SERVICE BULLETIN NO. SB-112-74

INSPECTION OF MAIN LANDING GEAR BRAKE TORQUE PLATE ASSEMBLY BOLT INSTALLATION

MODELS AFFECTED: Model 112/112B, S/N 3 thru 544 and 13000; Model 112TC/112TCA, S/N
13001 thru 13309;

Figure 1

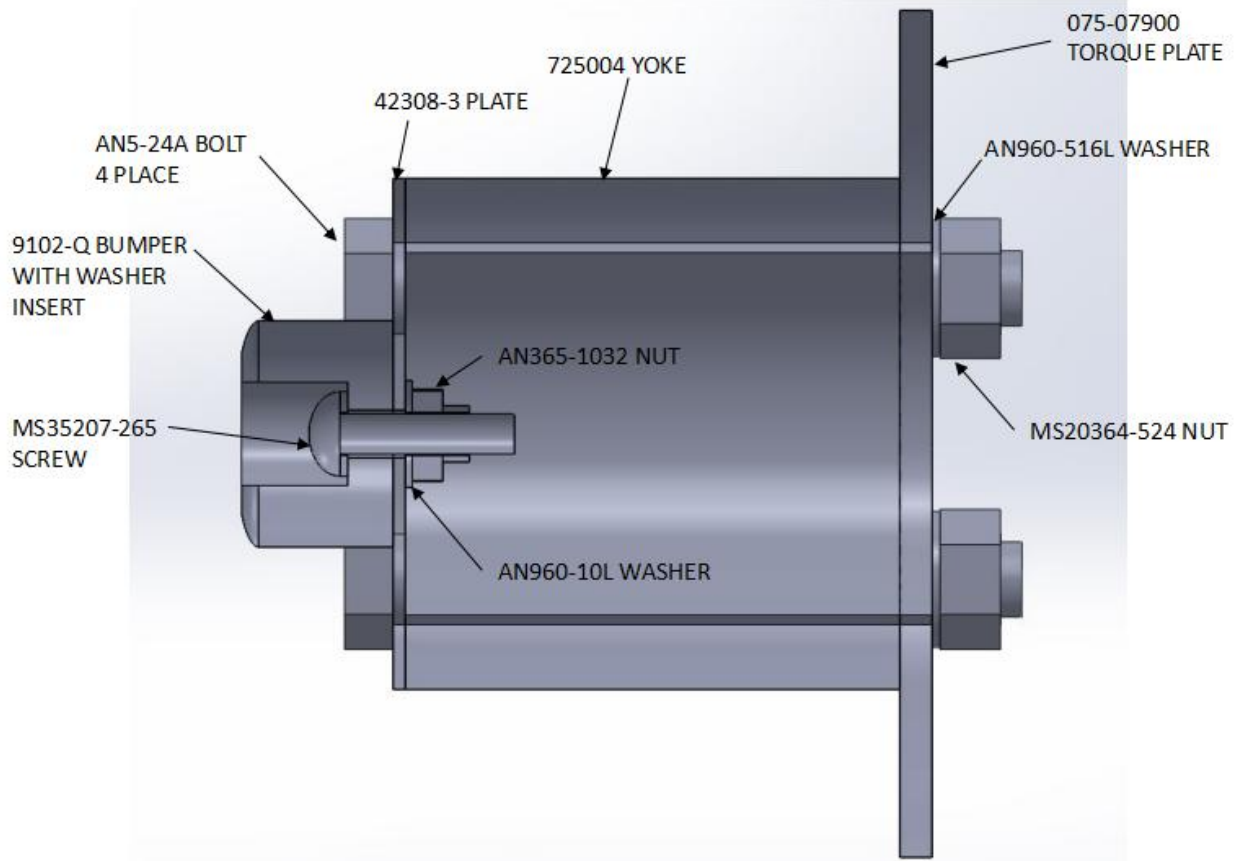
Determine that the AN5-24A bolts(4) are installed with the bolt heads on the inboard side of the Main Landing Gear yoke, common to the 42308-3 Plate(Refer to figure 1). Using an inspection mirror, determine

that AN960-516L washers and MS20364-524 nuts are installed with a minimum of 1 thread through the nut. If minimum thread protrusion is showing, no further change is required.

4. If minimum thread protrusion is not showing, replace the bolt(s) with AN5-25A bolts.
5. If bolt ends and nuts are showing on the inboard side of the Main Landing Gear yoke, the bolts must be reversed in order to provide required clearance between the Main Landing Gear and wing structure. Possibility of interference between bolt(s) with excess thread protrusion and structure must also be avoided.

Bolt thread protrusion through the nut on the now reversed bolts must be a minimum of 1 thread through the nut. For assemblies without minimum thread protrusion, replace bolts using AN5-25A bolts.

Torque all bolts per the Model 112 Maintenance Manual (60-85 IN-LBS above running torque).

Figure 2

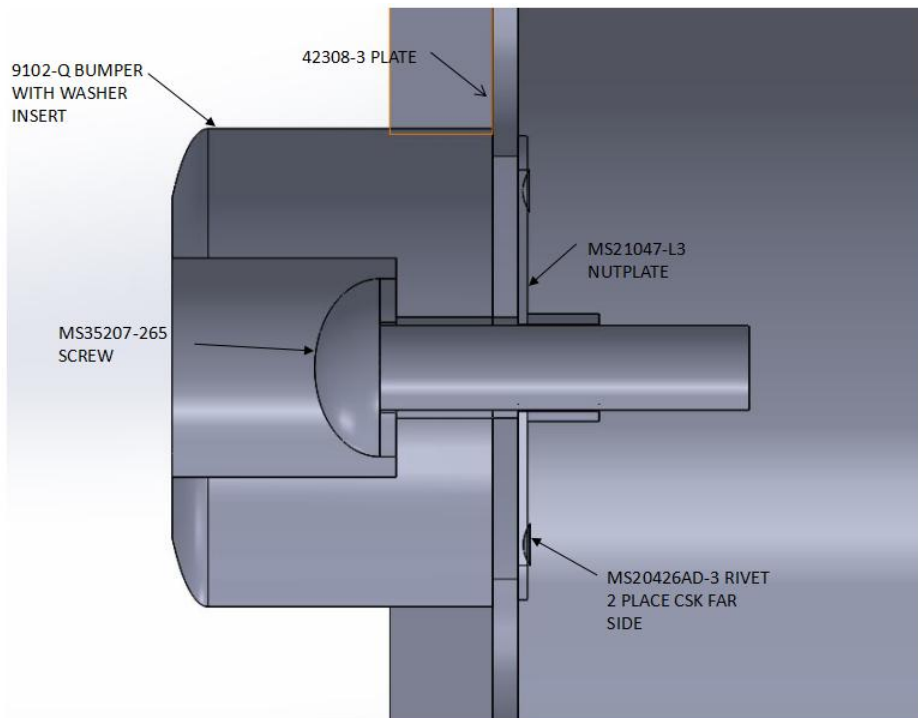
3. If required, replace the 9102-Q Bumper. To ease replacement of the 9102-Q Bumper, or equivalent 65+/-5 SDH Neoprene rubber bumper, it is recommended that the 42308-3 Plate be modified to 42308-501 Plate Assembly by installing a MS21047-L3 nutplate (Refer to figure 2). The 42308-501 Plate Assembly is common to late production Model 114B/114TC aircraft and is allowable for all spares.
